Access Compliance Report

Public Rights-of-Way

Intersection ID: 4080	Main Street: DAVID_COX_RD	Cross Street: REDBRIDGE_TL	Location: SW
ADA ID: 4D20FE69F999	Ramp Type: PerpDiag	Initial Pass/Fail: Fail	Overall Compliance: No
		Severity Score: 25

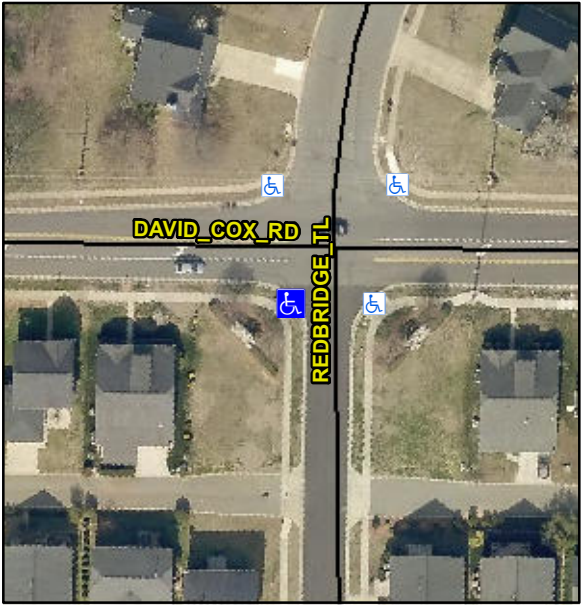
Codes/Mitigation Info/Possible Solution			Field Measurements/Component Compliance		
	Possible Solutions:		Compliance	Description	Data
	Remove & Replace Curb Ramp With Two New Directional Ramps or Equivalent.		Yes	Ramp Length (in)	64.0
			N/A	Ramp Width (in)	48.0
			N/A	Flare Type LT	N/A
			N/A	Flare Slope LT (%)	N/A
			N/A	Flare Traversable LT?	N/A
			N/A	Landing Length (in)	N/A
			N/A	Landing Width (in)	N/A
			N/A	Landing Slope (%)	N/A
			N/A	Landing X Slope (%)	N/A
			N/A	Landing Curb? (Y/N)	N/A
			N/A	Shared Landing?	N/A
			N/A	Gutter Ponding?	N/A
			N/A	Gutter Lip Ht (in)	N/A
			No	Painted X Walk1?	N/A
			To E	X Walk 1 Direction	To N
			N/A	X Walk 1 Width (in)	N/A

1.3	X Walk 1 Slope (%)	6.5
			7.0	X Walk 1 X Slope (%)	2.7
			N/A	Ramp inside XWalk1?	N/A
<p>Surveyor Notes:</p> <p>N/A</p> <p>PROW/ADA:</p> <p>Not Found, R304.5.3</p>			N/A	Ramp inside XWalk2?	N/A
